STRINGFELLOW SUBDIVISION

APPLICATION NUMBER 9 DATE June 21, 2007

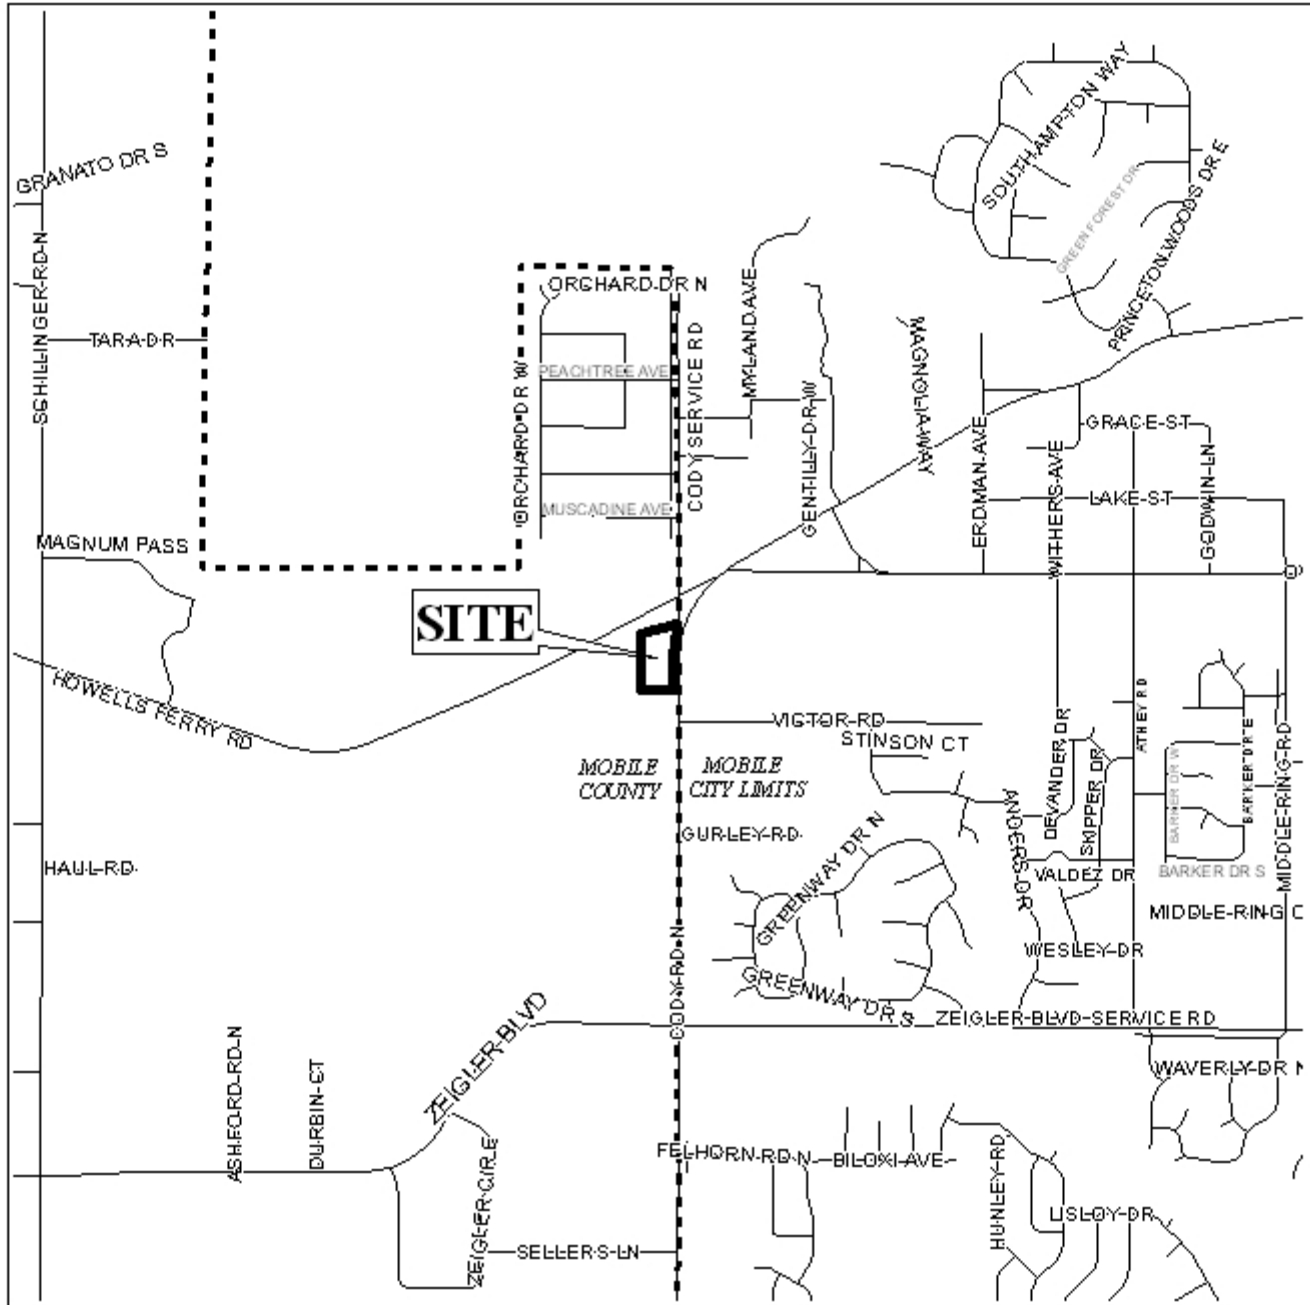
The site has road frontage on Cody Road which is shown as a major street on the Major Street Plan component of the Comprehensive Plan. The plat submitted indicates that Cody Road has a current 80' right-of-way along the property, and a minimum of 100' right of way is required by the Major Street Plan. Therefore; the dedication of sufficient right of way along Cody Road to provide 50' from centerline will be required.

Both lots would have frontage on Cody Road; therefore, Lot 1 should be limited to two curb cuts and Lot 2 should be limited to one curb cut to Cody Road, with the size, location, and design to be approved by the Mobile County Engineering Department.

The plat depicts the minimum building setback line from the current right of way line of Cody Road. This should be adjusted on the final plat to be depicted from the dedicated frontage along Cody Road.

Since this site is in the County, a note should be placed on the final plat stating that any lots which are developed commercially and adjoin residentially developed property must provide a buffer in compliance with Section V.A.7. of the Subdivision Regulations.

- 1) dedication of sufficient right-of-way to provide 50' from the centerline of Cody Road;
- 2) placement of a note on the Final Plat stating that Lot 1 is limited to two curb cuts to Cody Road, and Lot 2 is limited to one curb cut to Cody Road, with the size, location, and design of all curb cuts to be approved by the Mobile County Engineering Department;

- 3) adjustment of the minimum building setback line to be measured from the dedicated right-of-way along Cody Road;
- 4) placement of a note on the Final Plat stating that any lots which are developed commercially and adjoin residentially developed property must provide a buffer, in compliance with Section V.A.7. of the Subdivision Regulations;
